Exhibit 1: Brooks Atkinson Theater

Exhibit 1B: Architectural Modifications

Exh. 1B Architectural Modifications to Brooks Atkinson Theater

**5. MINSKOFF THEATER
ORCHESTRA LEVEL HOUSE RIGHT - MEN TOILET ROOM PLAN**

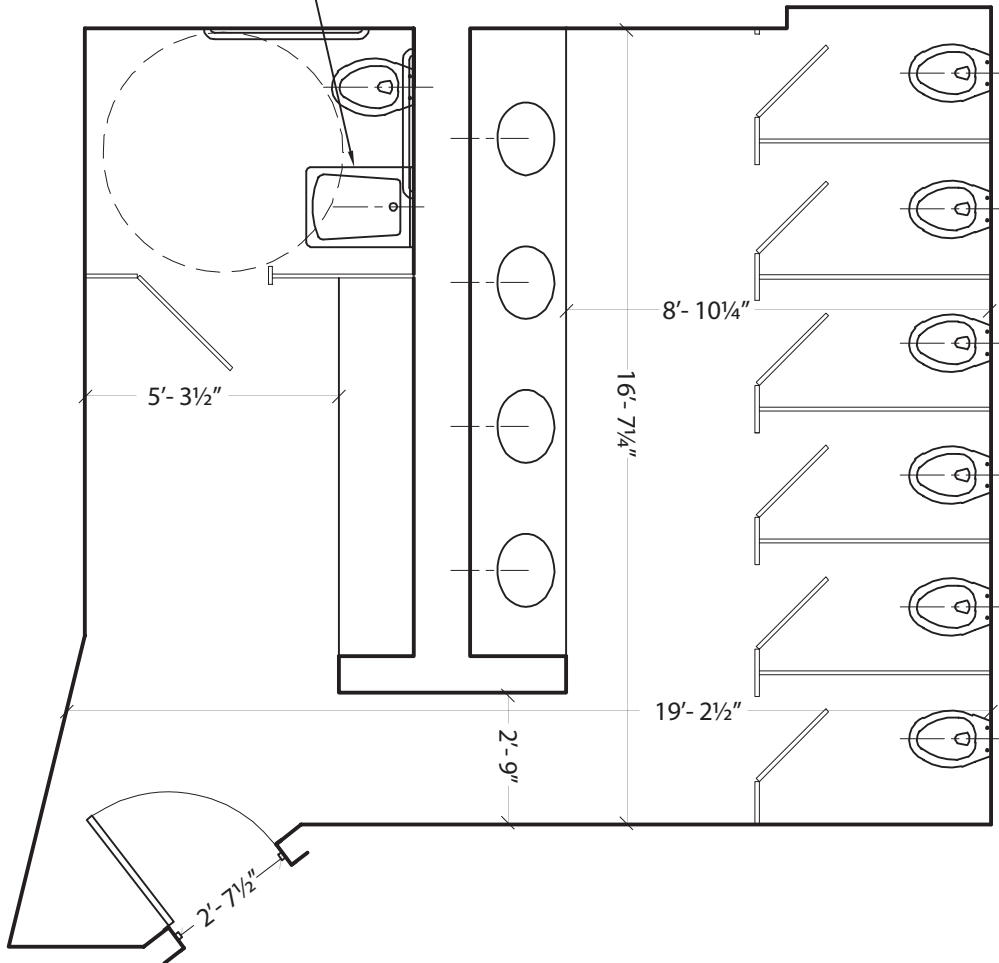
INSTALL NEW COMPLIANT
LAVATORY

Line #	Location Description	Existing Condition	Barrier Removal	1991 Standards Reference	Architectural Modification
23	Orchestra Level House Right (Men's Toilet Room)	The toilet paper dispenser is 2 1/2" above the side grab bar and is mounted at 41" from the rear wall.	Relocate the existing compliant toilet paper dispenser as required, ensuring 1 1/2" clearance below the grab bar or 12" above the grab bar.	4.1.3(11) 4.22.7 4.16.6 Fig. 29 Fig. 30	Defendant will provide toilet paper dispenser at compliant mounting height.
24	Orchestra Level House Right (Men's Toilet Room)	Though this facility provides audible fire alarms, there is no visual signal in this toilet room.	When alarm system is upgraded or replaced, add compliant visual signal that is integrated with the existing audible alarm system.	4.1.3(14) 4.28.1 4.28.2	Defendant will comply with code when system is upgraded.
25	Orchestra Level House Right (Men's Toilet Room)	Faucet controls require grasping, pinching, or twisting to operate.	Replace handle(s) with compliant type or replace faucet with compliant type. Lever operated, push type, and automatic mechanisms are acceptable.	4.1.3(11) 4.22.6 4.19.5 4.27.4	Defendant will provide compliant faucets.

26	Orchestra Level House Right (Men's Toilet Room)	The stall door is 34" wide with 31" clear width. The accessible stall is 55 1/2" deep x 65" wide with an outswinging stall door.	Replace door posts and door to provide required opening. Coordinate with stall depth requirements (56" minimum for a wall-hung water closet) and hardware requirements.	4.1.6(3)(e)(ii) 4.17.3 Fig. 30	Defendant will modify partitions to comply with stall depth requirements.
27	Orchestra Level House Right (Men's Toilet Room)	The toilet stall door hardware requires pinching and twisting to operate.	Remove the existing operating hardware and install compliant hardware.	4.1.3(11) 4.22.2 4.17.5 4.13	Defendant will provide compliant hardware.
28	Orchestra Level House Right (Men's Toilet Room)	The counter mounted lavatory knee space is 23" AFF at the front edge and 25" at 8" back.	Modify the existing lavatory and/or counter for compliance.	4.1.3(11) 4.22.6 4.19.2 Fig. 31	Defendant will provide compliant accessible lavatory.

32	Orchestra Level House Right (Men's Toilet Room)	The side grab bar is 7" from the rear wall and extends 50" from the rear wall.	Remove the otherwise compliant grab bar and reinstall it in the required location.	4.1.3(11) 4.22.4 4.17.6 Fig. 30 4.26	Defendant will install compliant grab bar.
33	Orchestra Level House Right (Women's Toilet Room)	The existing 1/2" threshold is sloped steeper than 1:2 (50%).	Remove the existing threshold and install a compliant threshold.	4.1.3(7)(c) 4.1.6(3)(d)(ii) 4.13.8 4.5.2 Fig.7(c) Fig.7(d) 4.7 4.8	Defendant will lower threshold to compliant height.
34	Orchestra Level House Right (Women's Toilet Room)	The rear grab bar is mounted vertically.	Remove the existing compliant rear grab bar and remount it in the required location.	4.1.3(11) 4.22.4 4.17.6 Fig. 30 4.26	Defendant will install compliant grab bar.

**5. MINSKOFF THEATER
ORCHESTRA LEVEL HOUSE LEFT - WOMEN TOILET ROOM PLAN**

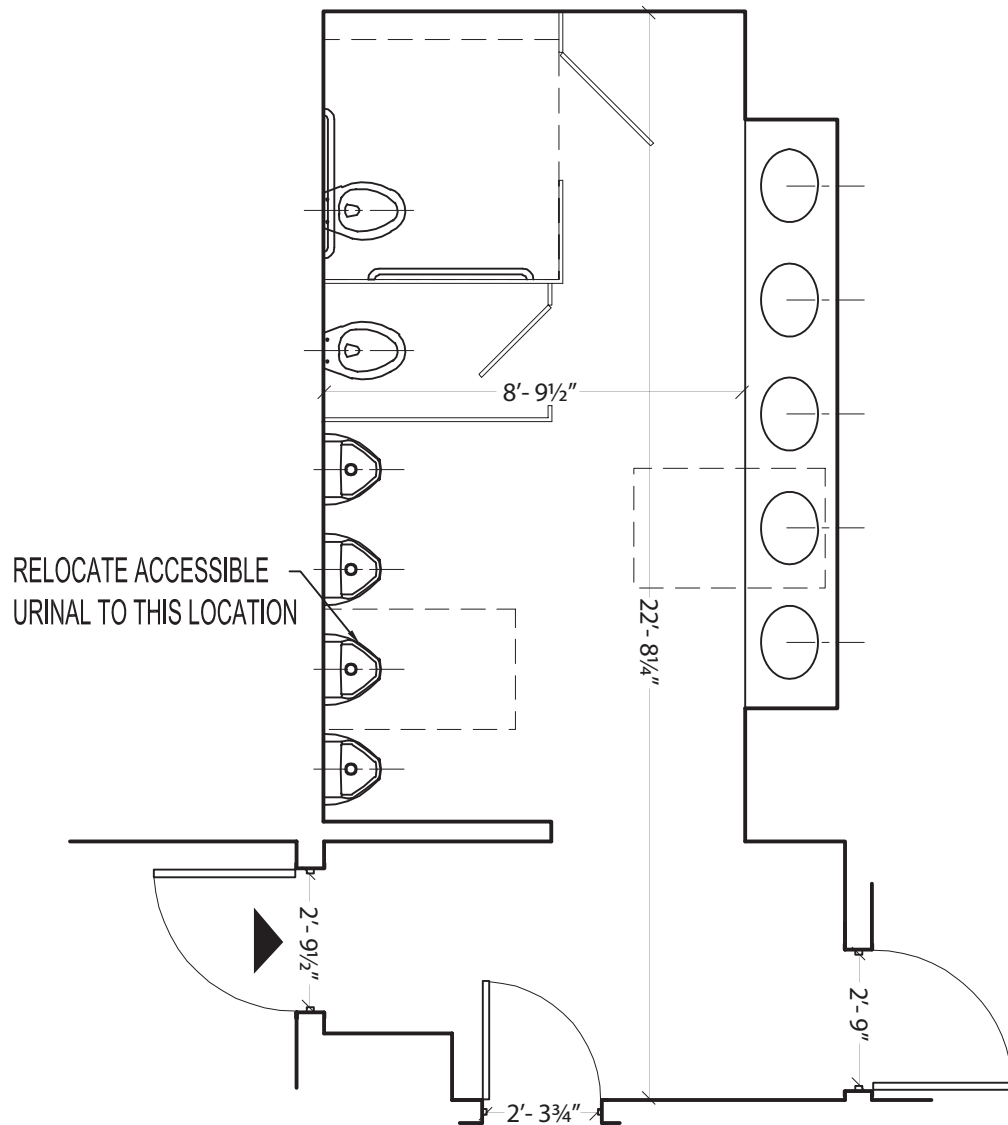
67	Orchestra Level (House Left Women's Toilet Room)	The water closet is located 14" centerline to the partition and is 18" AFF. Verify the toilet seat height in the accessible stall.	Reconfigure toilet partitions or move existing compliant water closet to the required position.	4.17.2 4.16 Fig. 30	Defendant will relocate water closet.
68	Orchestra Level (House Left Women's Toilet Room)	The rear grab bar is 36" long and is mounted vertically.	Remove the existing compliant rear grab bar and remount it in the required location.	4.1.3(11) 4.22.4 4.17.6 Fig. 30 4.26	Defendant will provide compliant rear grab bar.
69	Orchestra Level (House Left Women's Toilet Room)	Though this facility provides audible fire alarms, there is no visual signal in this toilet room.	When alarm system is upgraded or replaced, add compliant visual signal that is integrated with the existing audible alarm system.	4.1.3(14) 4.28.1 4.28.2	Defendant will comply with code when the system is upgraded.

70	Orchestra Level (House Left Women's Toilet Room)	The toilet paper dispenser is located 1 1/2" above the side grab bar and is mounted at 44" from the rear wall.	Relocate the existing compliant toilet paper dispenser as required, ensuring 1 1/2" clearance below the grab bar or 12" clear above the grab bar.	4.1.3(11) 4.22.7 4.16.6 Fig. 29 Fig. 30	Defendant will provide toilet paper dispenser at compliant mounting height.

74	Orchestra Level (House Left Women's Toilet Room)	The toilet stall door hardware requires pinching and twisting to operate.	Remove the existing operating hardware and install compliant hardware.	4.1.3(11) 4.22.2 4.17.5 4.13	Defendant will provide compliant hardware.
75	Orchestra Level (House Left Women's Toilet Room)	The wall mounted lavatory is 35" AFF to the rim.	Lower the existing compliant wall mounted fixture to the required height.	4.1.3(11) 4.22.6 4.19.2 Fig. 31	Defendant will provide accessible lavatory.
76	Orchestra Level (House Left Women's Toilet Room)	There is no raised lettering and Braille room identification sign provided at this gender specific multi-user toilet room.	Install compliant (includes raised lettering and Braille) room identification signage adjacent to strike side of door at 60" AFF to centerline. Coordinate with requirement for close approach without encountering protruding object or door swing.	4.1.3(16)(a) 4.30.1 4.30.4 4.30.5 4.30.6	Defendant will provide compliant signage.

Line #	Location Description	Existing Condition	Barrier Removal	1991 Standards Reference	Architectural Modification
78	Orchestra Level (House Left Women's Toilet Room)	The accessible stall is 58"-61" wide x 81" long at the end of the row.	Alter partitions to provide 60" minimum width.	4.1.3(11) 4.22.4 4.1.6(3)(e)(ii) 4.17.3 Fig. 30	Defendant will alter partitions for compliance.
79	Orchestra Level (House Left Women's Toilet Room)	The manual flush control is located on the side of the water closet closest to the side wall.	When replacing or relocating the water closet to correct other deficiencies, ensure the flush control is on the wide side of the water closet.	4.1.3(11) 4.22.4 4.16.5	Defendant will provide compliant flushing control.
80	Orchestra Level (House Left Women's Toilet Room)	The door provides 31" clear width at 90 degrees open.	Remove the existing door, widen opening and install a new door that provides the minimum required clear width. Coordinate with maneuvering clearance and closer requirements.	4.1.3(7)(c) 4.13.5 Fig. 24	Defendant will install compliant door. Should maneuvering clearances not be compliant, will install automatic door.

**5. MINSKOFF THEATER
ORCHESTRA LEVEL HOUSE LEFT - MEN TOILET ROOM PLAN**

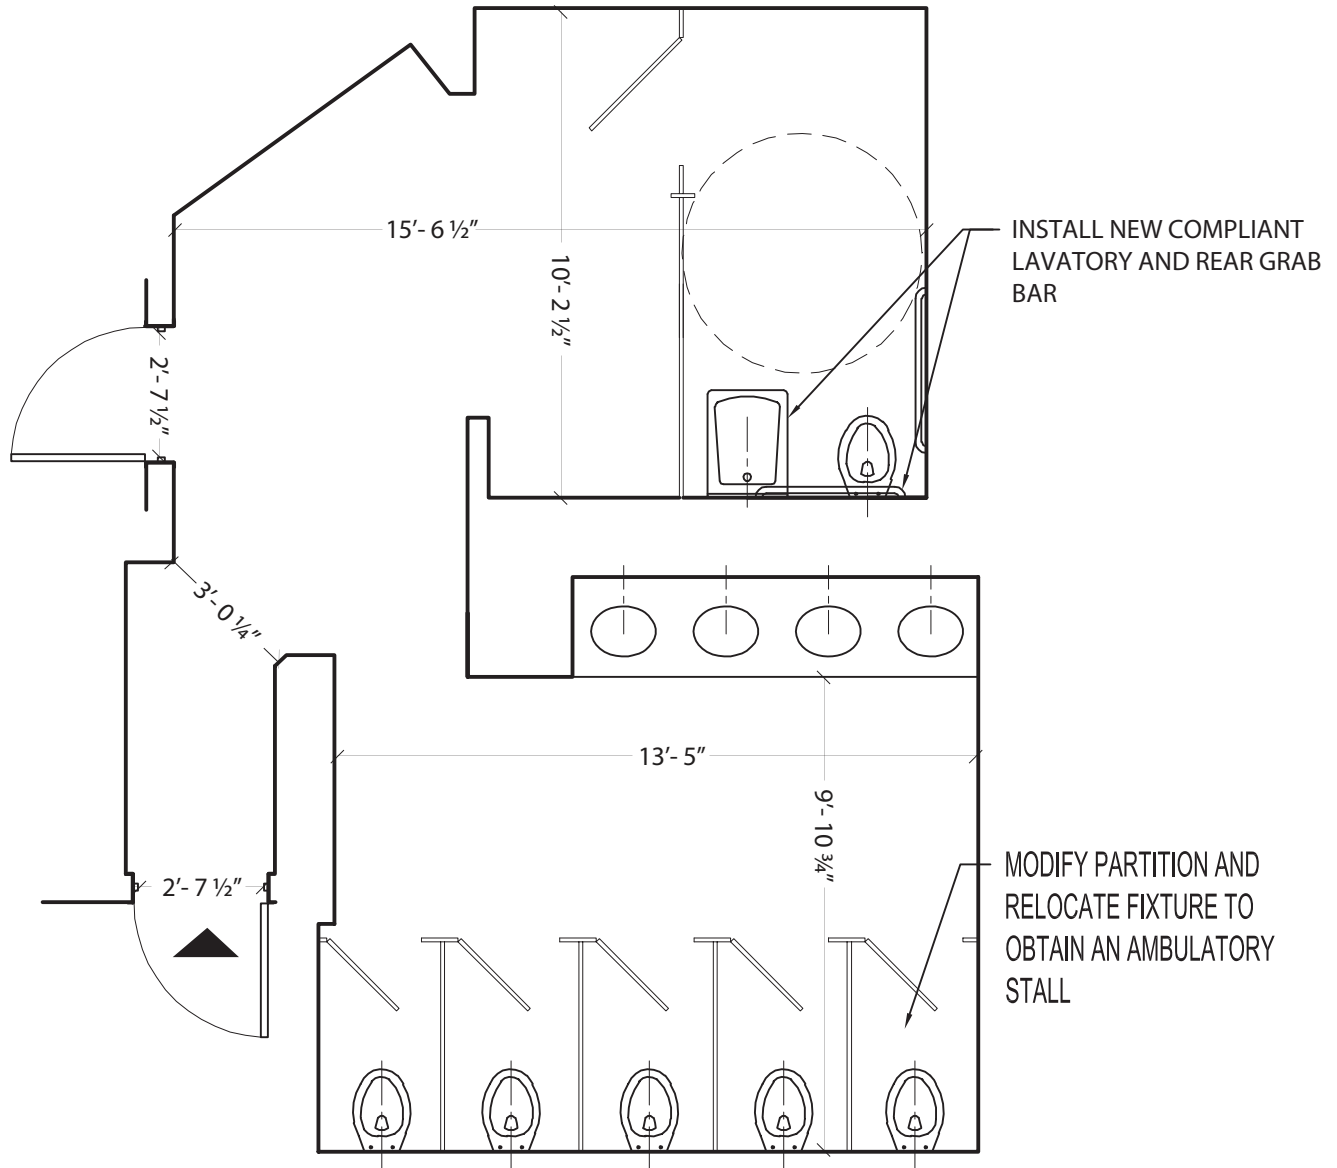
Line #	Location Description	Existing Condition	Barrier Removal	1991 Standards Reference	Architectural Modification
53	Orchestra Level (House Left Men's Toilet Room)	The rear grab bar is located 24" from the side wall.	Remove the existing compliant rear grab bar and remount it in the required location.	4.1.3(11) 4.22.4 4.17.6 Fig. 30 4.26	Defendant will provide compliant rear grab bars.
54	Orchestra Level (House Left Men's Toilet Room)	The toilet paper dispenser is located 3" above the side grab bar and is mounted at 36 3/4" from the rear wall.	Relocate the existing compliant toilet paper dispenser as required, ensuring 1," clearance below the grab bar or 12" above the grab bar.	4.1.3(11) 4.22.7 4.16.6 Fig. 29 Fig. 30	Defendant will provide compliant toilet paper dispenser.
55	Orchestra Level (House Left Men's Toilet Room)	Though this facility provides audible fire alarms, there is no visual signal in this toilet room.	When alarm system is upgraded or replaced, add compliant visual signal that is integrated with the existing audible alarm system.	4.1.3(14) 4.28.1 4.28.2	No alarm system upgrade is scheduled at this time.

56	Orchestra Level (House Left Men's Toilet Room)	Faucet controls require grasping, pinching, or twisting to operate.	Replace handle(s) with compliant type or replace faucet with compliant type. Lever operated, push type, and automatic mechanisms are acceptable.	4.1.3(11) 4.22.6 4.19.5 4.27.4	Defendant will provide compliant faucets.
57	Orchestra Level (House Left Men's Toilet Room)	The counter mounted lavatory knee clearance is 23" at the front edge and 32" AFF to the rim.	Modify the existing lavatory and/or counter for compliance.	4.1.3(11) 4.22.6 4.19.2 Fig. 31	Defendant will provide accessible lavatory.
58	Orchestra Level (House Left Men's Toilet Room)	The soap dispenser is located at 22 1/2" depth at 37" AFF over the lavatory.	Relocate the existing soap dispenser within reach range.	4.1.3(11) 4.22.7 4.27 4.2.5 4.2.6	Defendant will provide accessible mounting height of soap dispenser.
59	Orchestra Level (House Left Men's Toilet Room)	The toilet stall door hardware requires pinching and twisting to operate.	Remove the existing operating hardware and install compliant hardware.	4.1.3(11) 4.22.2 4.17.5 4.13	Defendant will provide compliant hardware.

Line #	Location Description	Existing Condition	Barrier Removal	1991 Standards Reference	Architectural Modification
65	Orchestra Level (House Left Men's Toilet Room)	The door provides 31" clear width at 90° open. The toilet room door is a non-fire rated door that requires 11 pounds of force to open.	Remove the existing door, widen opening and install a new door that provides the minimum required clear width. Coordinate with maneuvering clearance and closer requirements.	4.1.3(7)(c) 4.13.5 Fig. 24	Defendant will install compliant door. Should maneuvering clearances not be compliant, will install automatic door.
66	Orchestra Level (House Left Men's Toilet Room)	The water closet is located 17 1/2" centerline to the partition and is 16" AFF. Verify toilet seat height.	Replace seat with a thick model for compliant height or replace fixture with an accessible model.	4.1.3(11) 4.22.4 4.17.2 4.16 Fig. 30	Defendant will provide accessible toilet seat.

**7. NEIL SIMON THEATER
LOWER LEVEL - MENS' TOILET ROOM PLAN**

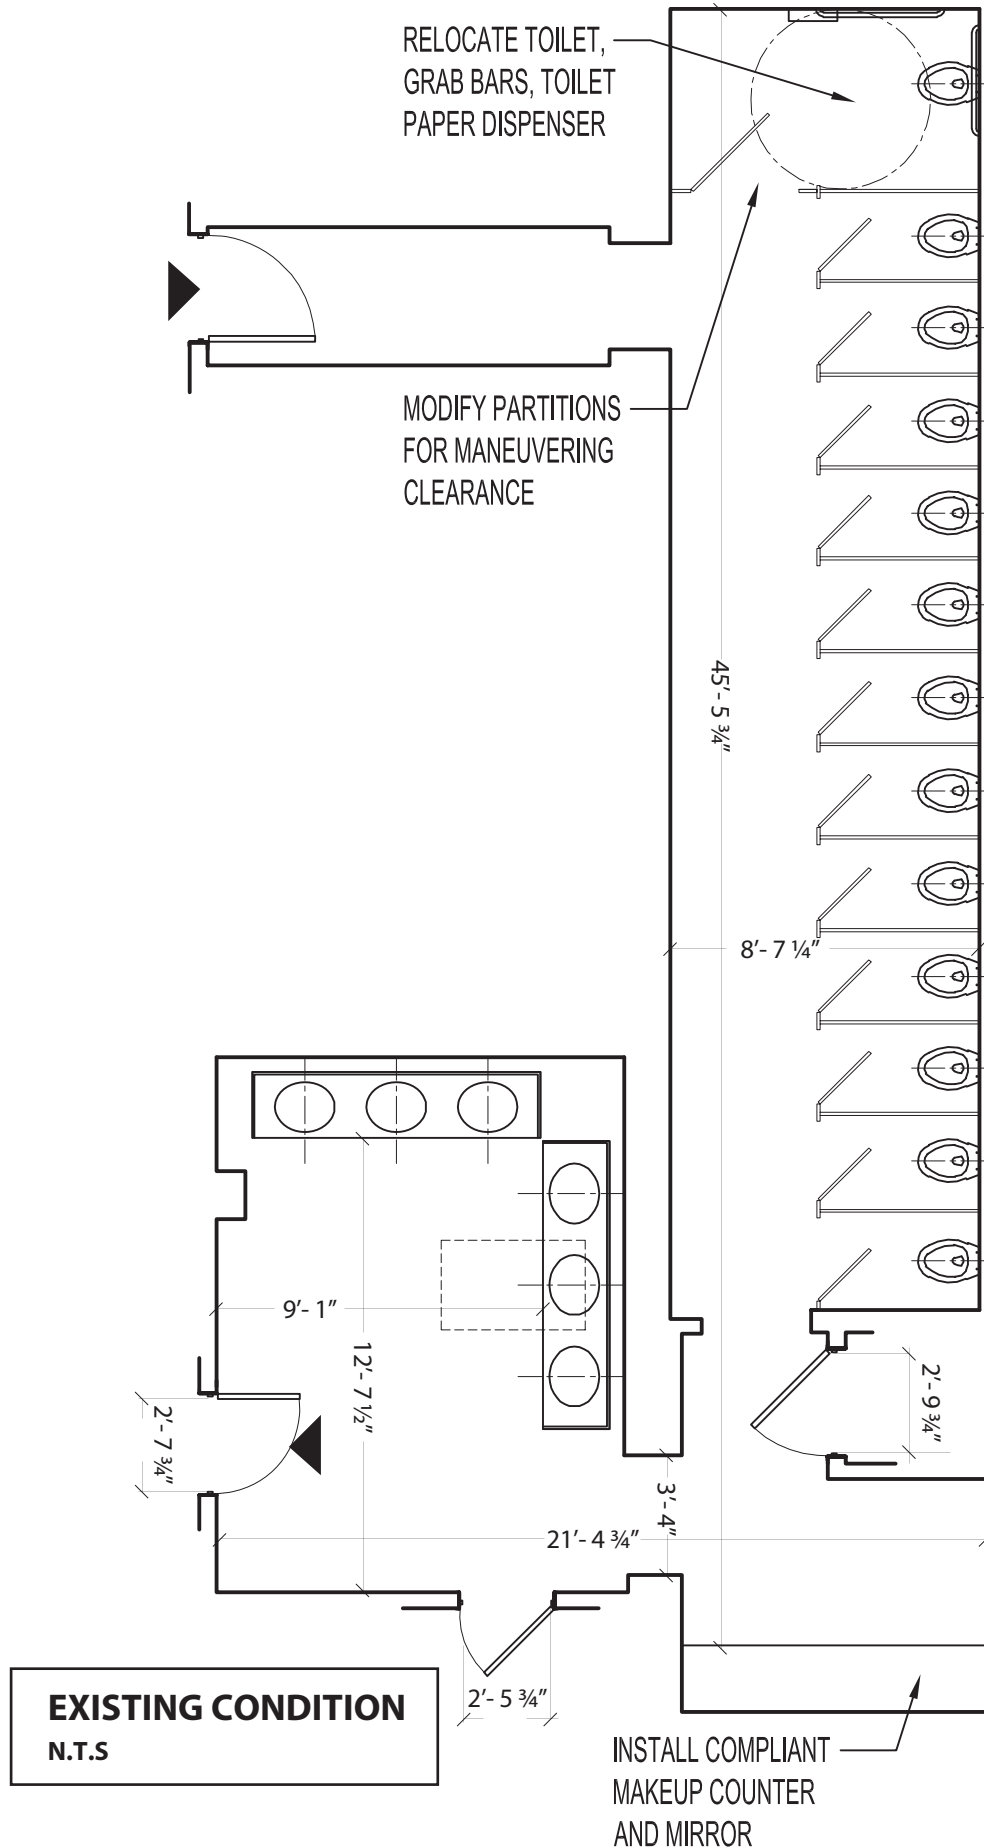
REMOVE TWO URINALS
AND INSTALL COMPLIANT
ELONGATED TYPE

10	Lower Level (Men's Toilet Room)	The bottom to the reflecting surface of the mirror is 48.5" AFF.	Lower existing mirror.	4.19.6 Fig. 31	Defendant will provide compliant mirror.
11	Lower Level (Men's Toilet Room)	There are 4 lavatories with 29" AFF knee clearance at the front edge, 28" AFF at 8" back.	Insulate hot water supply and drain pipes. Ensure that all other sharp or abrasive surfaces are properly covered or filed smooth.	4.19.4	Defendant will provide compliant pipe insulation.

Line	Location Description	Existing Condition	Possible Solution	1991 Standards Reference	Architectural Modification
12	Lower Level (Men's Toilet Room)	The drinking fountain spout outlet height is 42" AFF.	Install high-lo fountain or, as a readily achievable solution: install a flat- bottom cup dispenser at existing fixture within reach range not accommodated by existing drinking fountain. Coordinate with protruding object requirements.	4.1.3(10) 4.15 Fig. 27(a)	Defendant will provide compliant flat-bottom cup dispenser.
13	Lower Level (Men's Toilet Room)	There is no raised lettering and Braille room identification sign provided at this gender specific multi- user toilet room.	Install compliant (includes raised lettering and Braille) room identification signage adjacent to strike side of door at 60" AFF to centerline. Coordinate with requirement for close approach without encountering protruding object or door swing.	4.1.3(16)(a) 4.30.1 4.30.4 4.30.5 4.30.6	Defendant will provide compliant signage.
